| Project Title: | Fountain Wind Project |
| Document Title: | LU-002_LandUses1mile |

Fountain Wind Project Response to CEC Data Request LU-002

Follow-up Data Request LU-002:

V:\11950\active\Task_Owner and other Non-BC1956_Joist185703743\03_data\gis_cad\gis\mxd\2023\LU-002_LandUses1mile.mxd Revised: 2023-06-21 By: gaarpantler

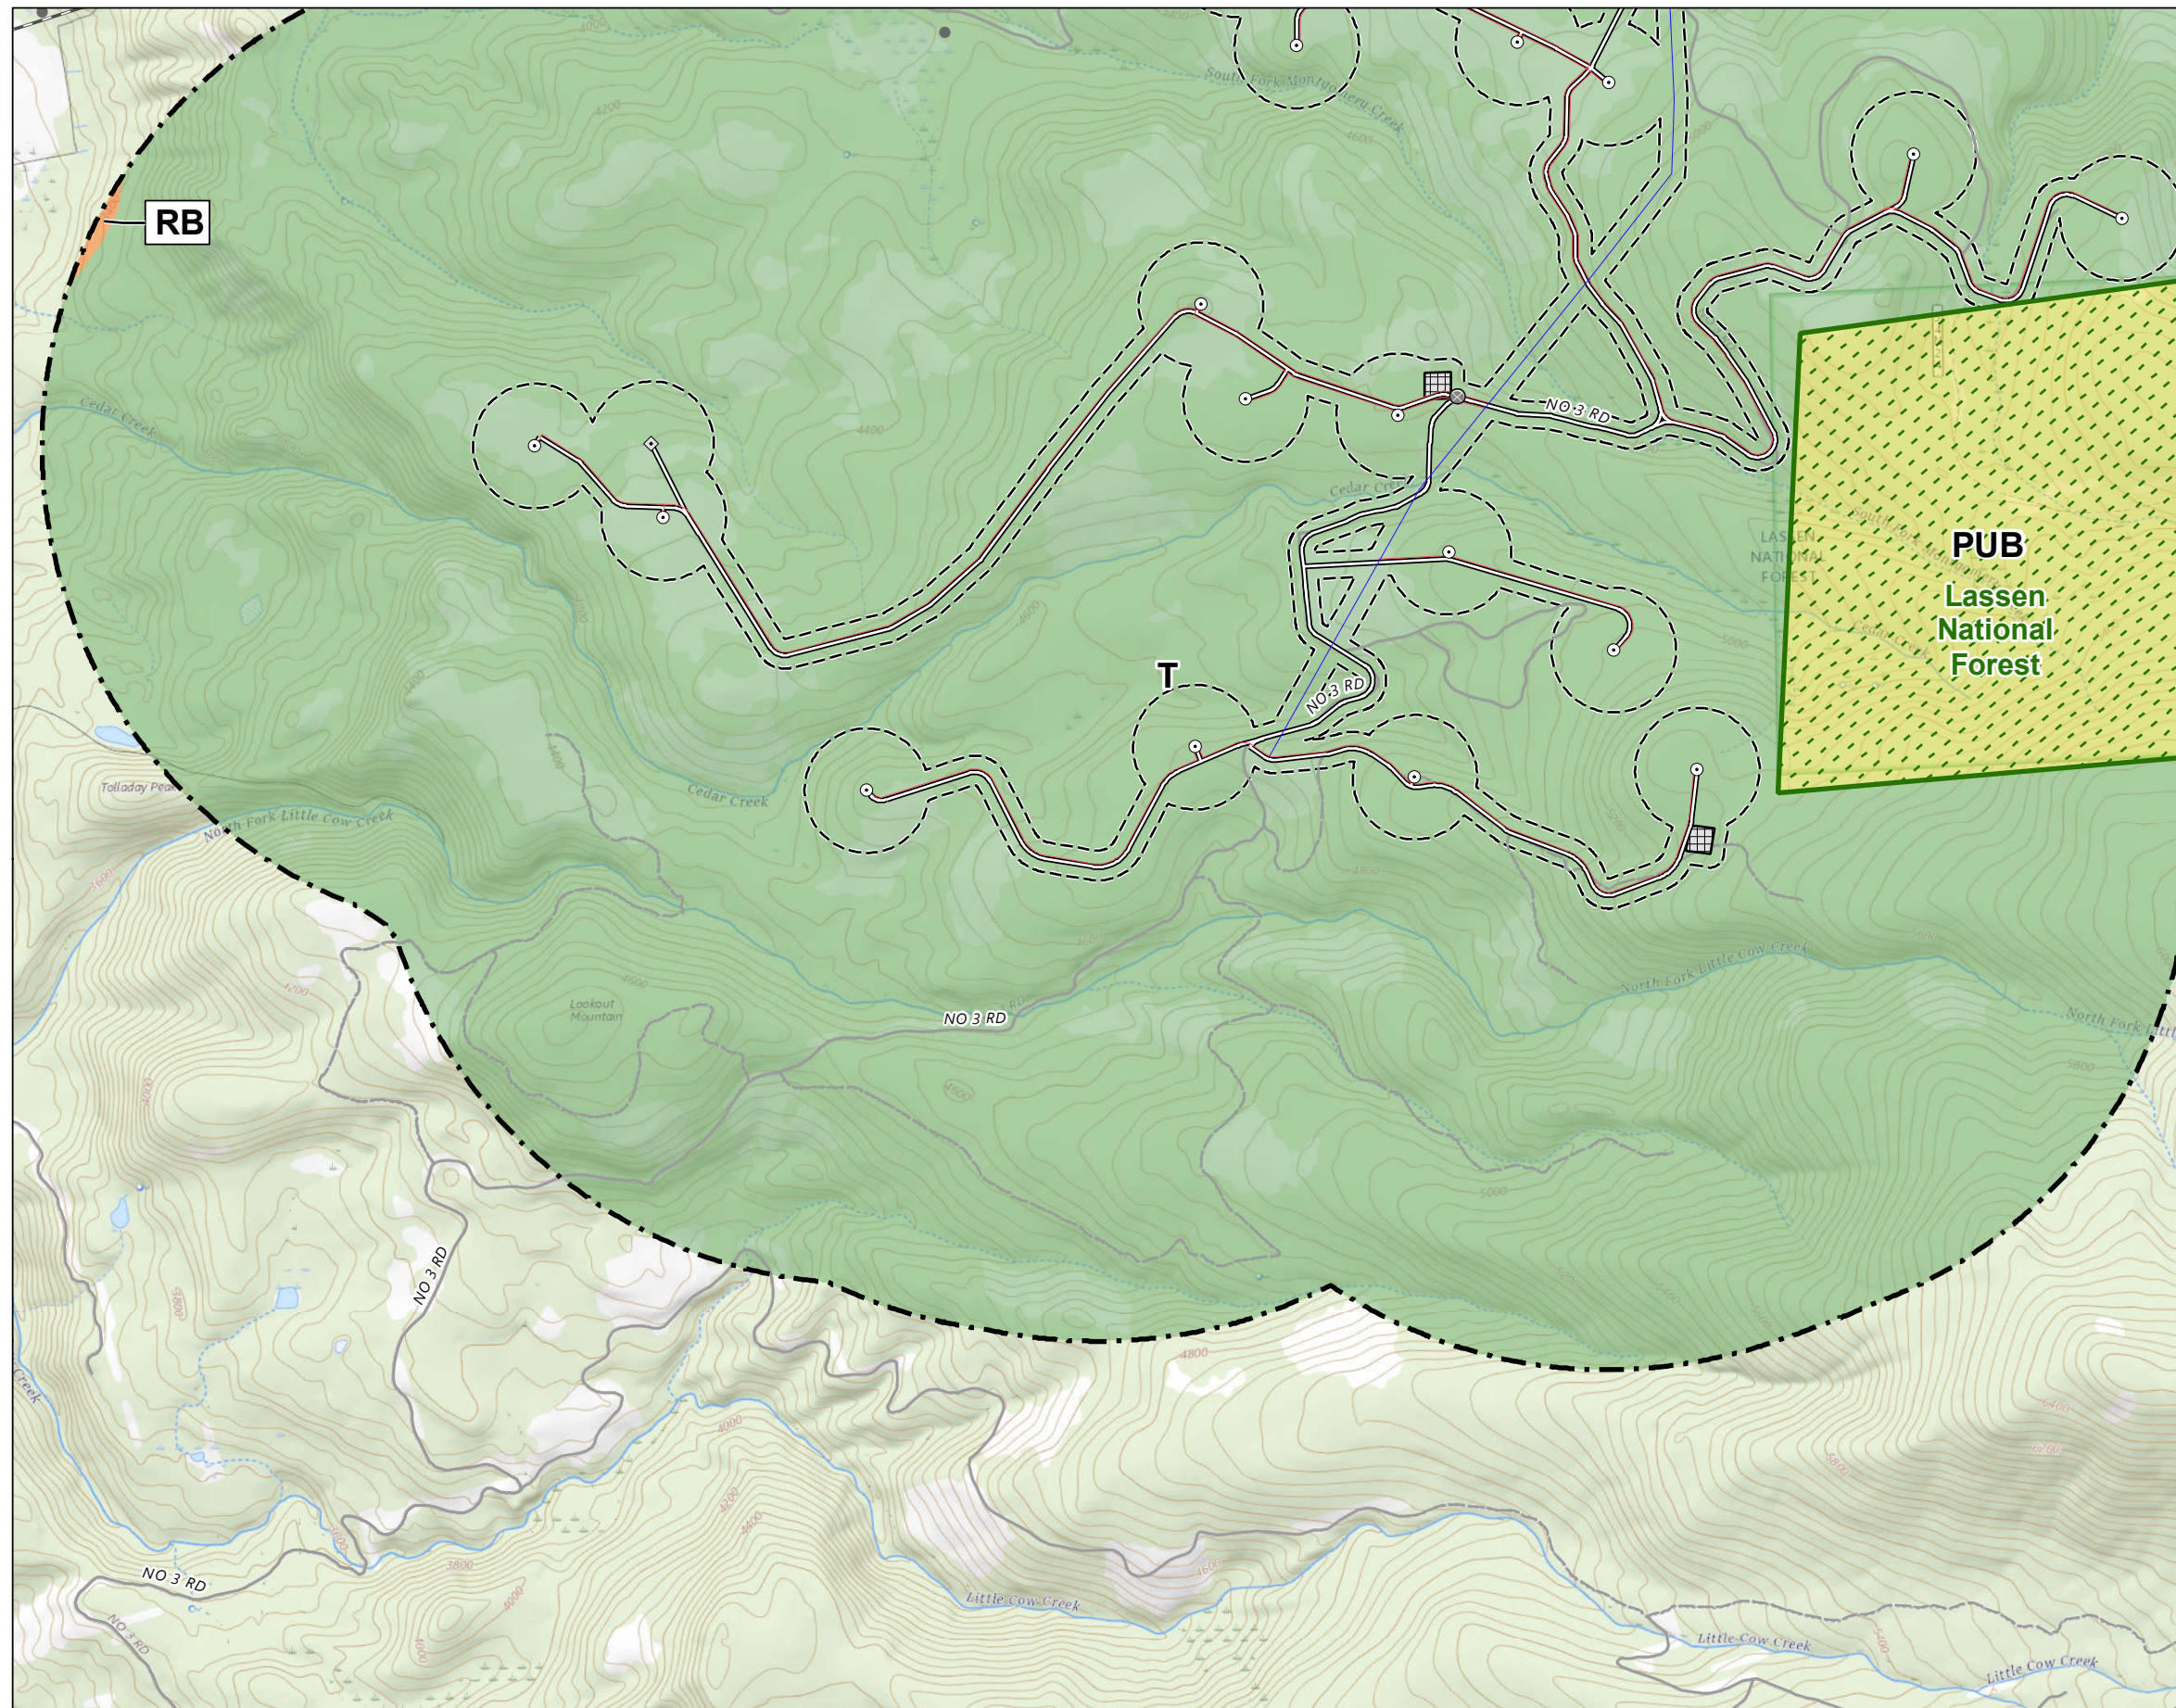
The information submitted is incomplete. TN 250283 (LU-02_LandUse) and TN 250448 (land_use_fwp_responses) are not adequate responses to the Warren-Alquist Act Siting Regulations Appendix B (g)(3)(A) and Appendix B (g)(3)(A)(i).

- The Project Site Boundary (i.e., the boundary that encompasses all project activities).
- The 1-mile buffer from the specific proposed Project Site Boundary, as required by the Warren-Alquist Act Siting Regulation Appendix B (g)(3)(A). The “buffer” illustrated in TN 250283 is not accurately shown as extending 1-mile from the project boundary. Note that a “project area” is not a specific project site boundary. The Applicant needs to provide the specific boundary upon which the Project would be sited to allow for CEQA impact analysis.

- The location of zoning designations that are identified in the figure legend for TN 250283 (i.e., Rural Residential is shown in the legend but is missing on the figure).

- Per the Warren-Alquist Act Siting Regulation Appendix B (g)(3)(A)(i), a discussion of existing physical land uses within the Project Site Boundary and 1-mile buffer area that include “residential, commercial, industrial, recreational, scenic, agricultural, natural resource protection, natural resource extraction, educational, religious, cultural, and historic areas, and any other area of unique land uses.” This discussion must include a description of the total numbers and locations of any existing residences; recreation facilities such as parks & trails; schools; commercial/retail sites; industrial uses or other land uses. Note that land use designations (i.e., general plan and zoning) are not the same as existing physical land uses currently occurring on the project site.

See revised figure LU-002. The Project Site Boundary includes all project features and all areas in which ground disturbing activities could potentially occur, and the associated construction and maintenance corridors and is depicted on Figure LU-002. Appendix B does not require an applicant to provide the total numbers of existing residences but the Applicant nonetheless estimates that there are approximately 50 rooftops that may be houses in the second home community of Moose Camp, and an additional 15 or so scattered throughout the 1-mile buffer. The remaining physical land uses are included in the table below.
